I am writing to object to the proposals submitted for the redevelopment of 21-31 New Oxford Street [2014/5946/P].

This complaint is sent in response to the amendments to the scheme which were resubmitted in December 2014. After careful study of the drawings and documentation I see that very little has been done to address my concerns and so the points raised below still stand.

Image B

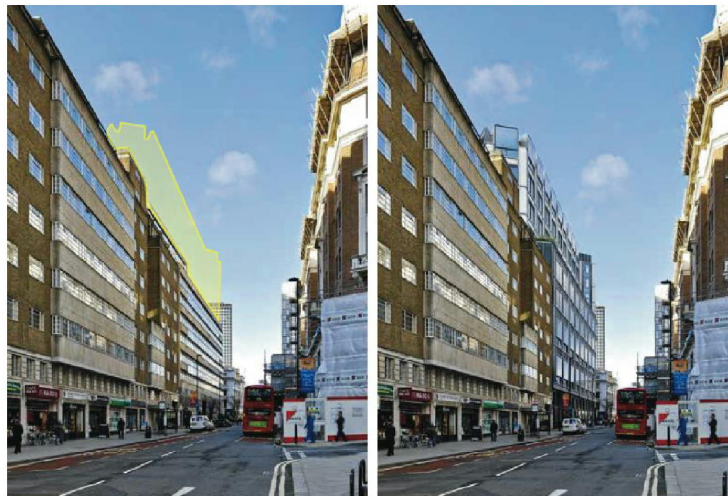
- The overall massing of the scheme is out of place with the existing location. The current building steps back so that its façades align with the surrounding buildings which is an acceptable approach to the overall massing. The proposals increase both the size vertically and horizontally creating a more dominating mass which is out of character with the surrounding conservation areas of Bloomsbury Conservation Area and Seven Dials (Covent Garden) Conservation Area. This increased mass also has a detrimental effect on the surroundings of Hawksmoor's Grade 1 listed St. George's Church. (see Image D below)
- The developer's Landscape and Visual Assessment Analysis shows the increased mass to be of a significant impact and overbearing nature on the surrounding buildings. See images below. (this effects key views from both the British Museum and Holborn Station)

View as moving away from the British Museum along Museum Street. This elevation has been altered slightly in the revised drawings but the main increase in bulk is still present.

Image D

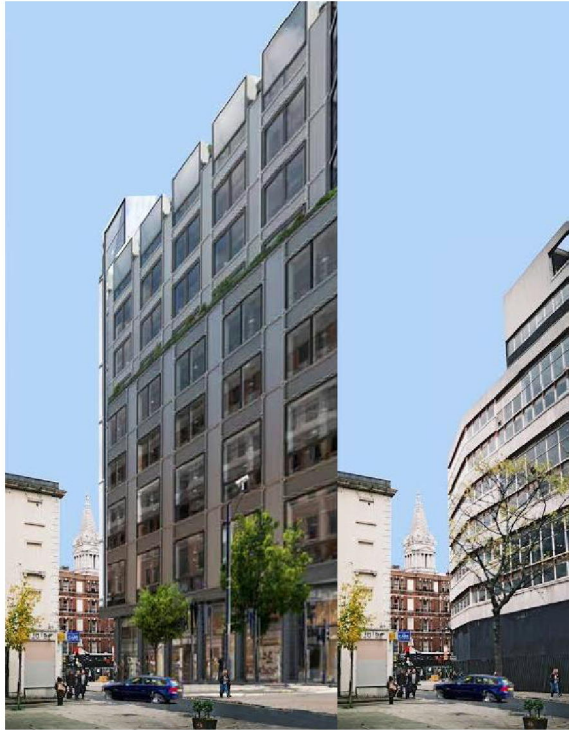
Image showing the effect of the proposal on key views of the Grade I listed St. George's Church.
